Work Order ID 109319

Item ID: D212-664-201

Item Name: Aft Crosstube - High

DRAWING NO. D212-664-241	TITLE CROSSTUBE ASSY (205/212 HI AFT)	REV. D	DART AEROSPACE LTD ENGINEERING ORDER		D.E.O. NO. D212-664-241-D-1	SHEET NO. SHEET 1 OF 2	SCALE NTS
DRAWN	CHECKED	MFG. APPR.	APPROVED	DE APPR.			
DATE 11.04.07	DATE 11.04.11	DATE 11.04.12	DATE 11/04/12	DATE 11.04.12

FIGURE 1: SUPPORT INSTALLATION

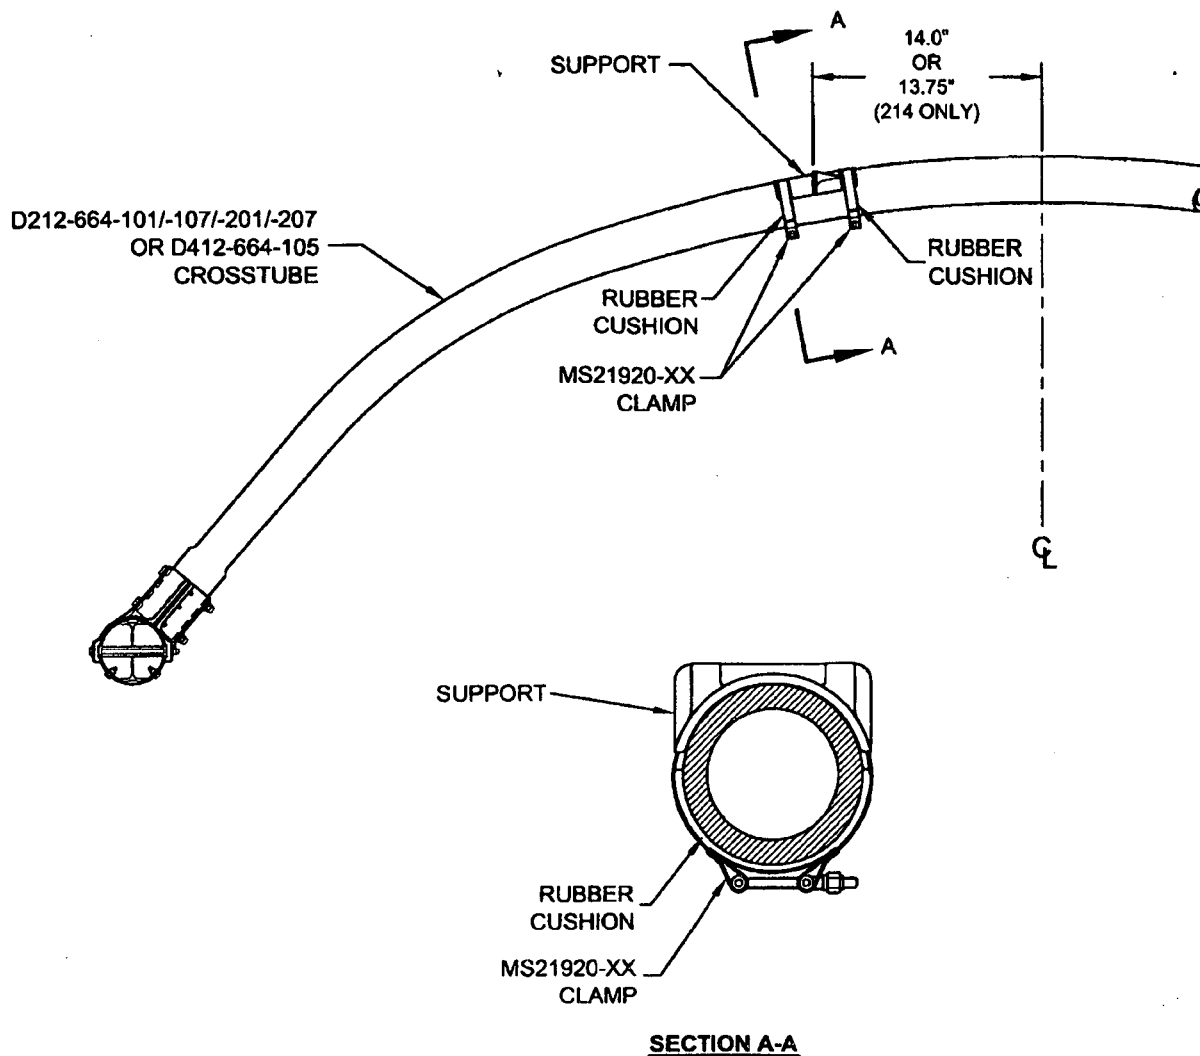
For the crosstubes listed above, section 32.4 of ICA-D212-664 is amended as follows. Use Figure 1 of this service instruction and Figures 32-2 to 32-9 of ICA-D212-664 for further reference. For crosstubes of an earlier change number, it is recommended that if the supports are removed, the supports should be reinstalled using the procedure listed below.

- 32.4.1 Locate the area on the crosstube for installation of support (see Figure 1 of this service instruction). For D212-664-101/-107/-201/-207 and D412-664-105 crosstubes, the outward face of the support tabs should be 14.0" (355mm) from the crosstube center for 204/205/210/412/UH-1 aircraft. For installation on 214B/B-1 aircraft, the outward face of the support tabs should be 13.75" (349mm). Ensure paint finish of crosstube is intact; touch up as required per Chapter 5 (5.3.9) of ICA-D212-664.

- 32.4.2 If present, remove any paint/primer on bottom of supports. Abrade mating surfaces of support and crosstube with 400-grit sandpaper. Saturate a clean cloth with MEK or 4105S Wash'n'Wipe Degreaser or equivalent and wipe until there is no residue.

- 32.4.5 Apply a 0.04" to 0.07" thick layer of Proseal 890 Class B or AMS-S-8802 Class B sealant underneath applicable support and install support as shown in Figure 1 of this service instruction.

- 32.4.6 Install the clamps opposite to crosstube support as shown in section A-A of Figure 1. Install rubber cushions underneath each clamp around the bottom circumference of the crosstube up to the crosstube centerline. Torque clamps 80-100 in-lb (9.0-11.3 Nm). It is acceptable to use smaller or larger sized MS21920-XX clamps than those listed in ICA-D212-664, ensure that after torquing the clamps per this instruction, the nuts are in safety but not bottomed out

**D212-664-241/-241B
ASSEMBLY DETAIL**

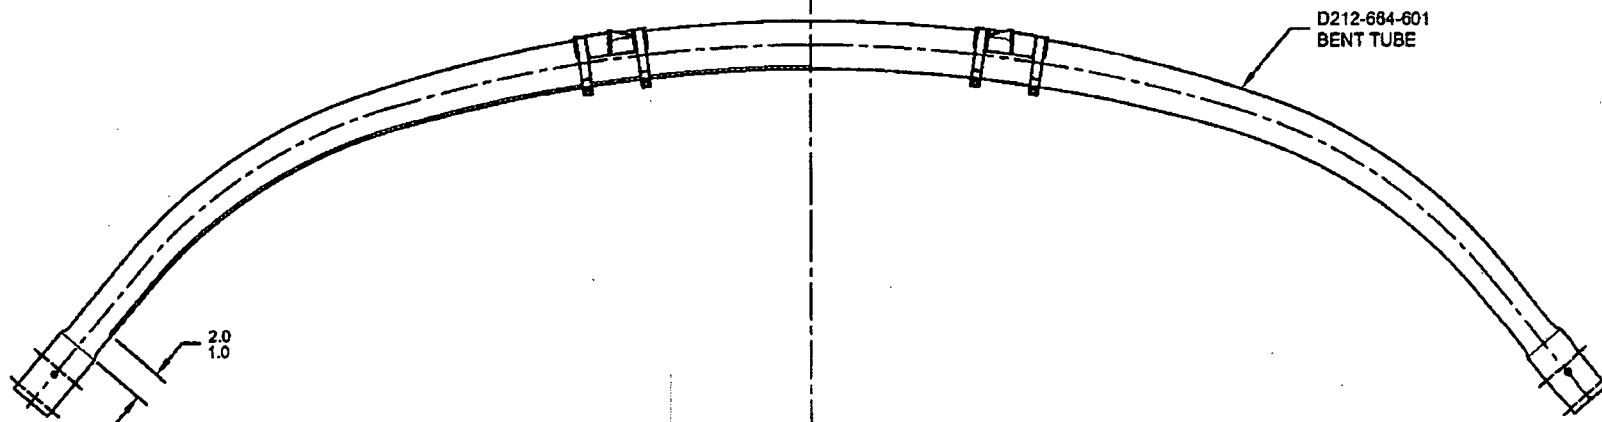
ADD AN INSPECTION WINDOW TO UNDERSIDE OF CROSSTUBE.

NOTES 2 OF SHEET 1 IS AMENDED AS FOLLOWS:

- 2) FINISH: CHEMICAL CONVERSION COAT PER DART QSI 005 4.1
PRIME INSIDE AND OUTSIDE PER DART QSI 005 4.2
MASK UNDERSIDE OF CROSSTUBE AS SHOWN (HATCHED AREA) AND
PAINT OUTSIDE PER DART QSI 005 4.2
REMOVE MASKING AND APPLY CLEAR COAT

MASK AREA PRIOR TO PAINTING,
REMOVE MASKING AFTER PAINT
AND APPLY CLEAR COAT
